Poland Municipal Center Master Plan

November, 2013

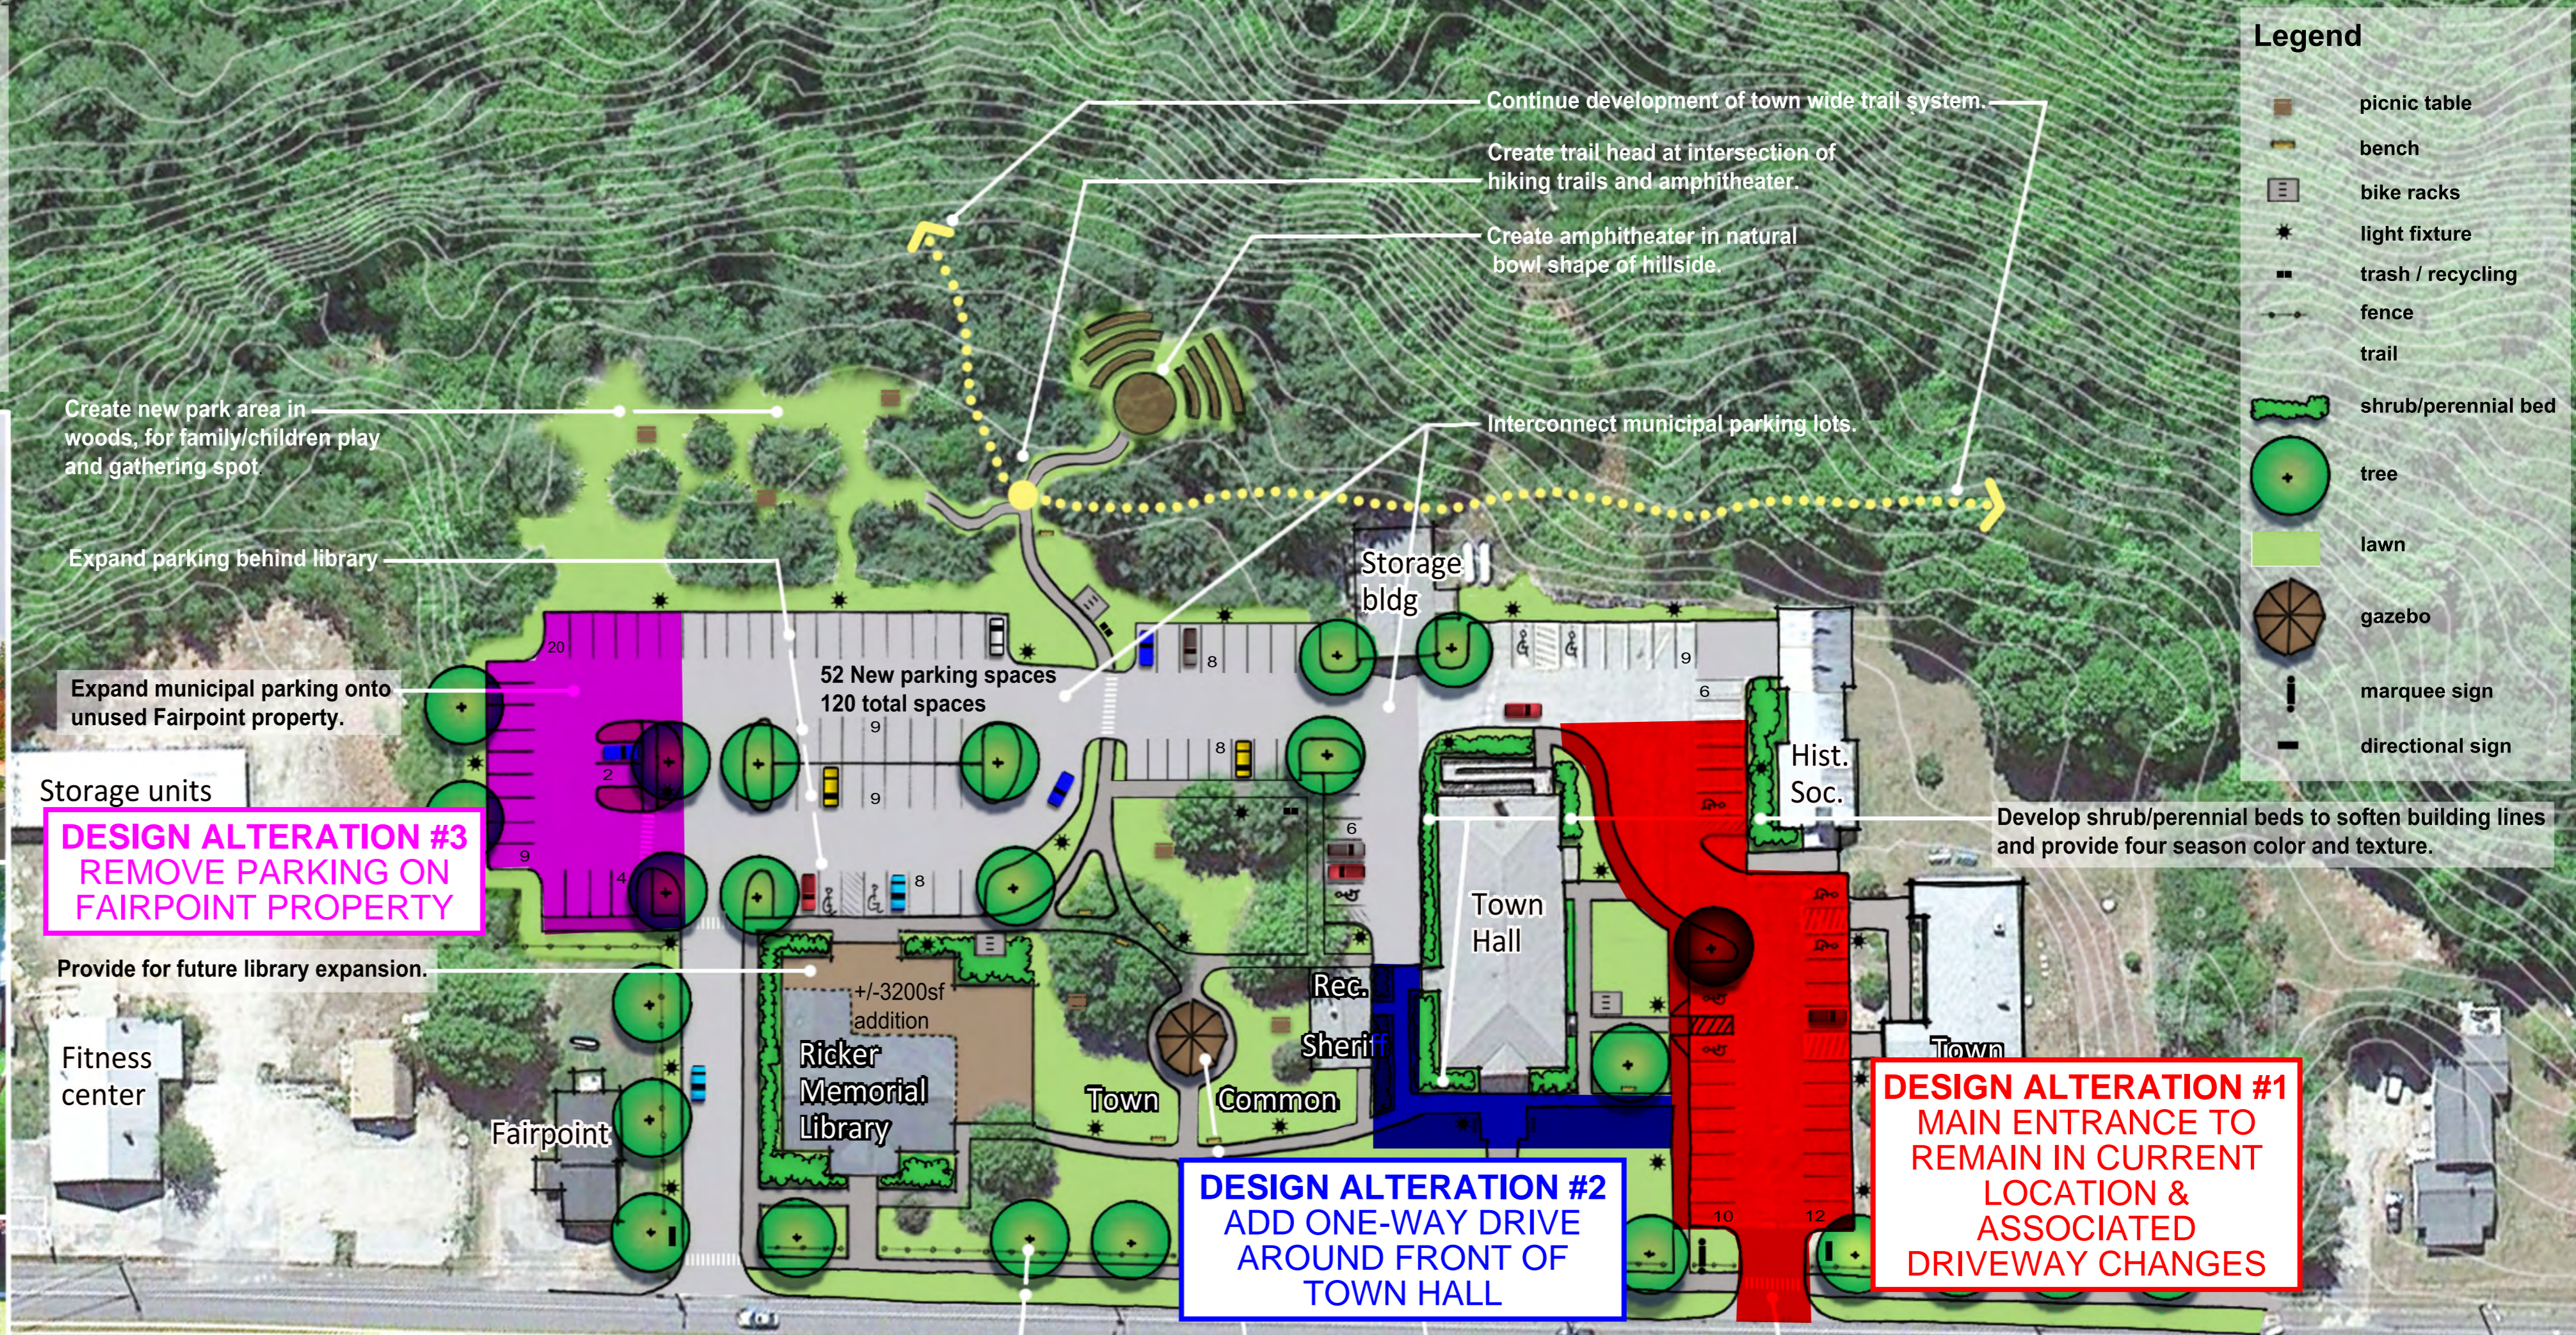
**DESIGN ALTERATION #3
REMOVE PARKING ON
FAIRPOINT PROPERTY**

**DESIGN ALTERATION #2
ADD ONE-WAY DRIVE
AROUND FRONT OF
TOWN HALL**

**DESIGN ALTERATION #1
MAIN ENTRANCE TO
REMAIN IN CURRENT
LOCATION &
ASSOCIATED
DRIVEWAY CHANGES**
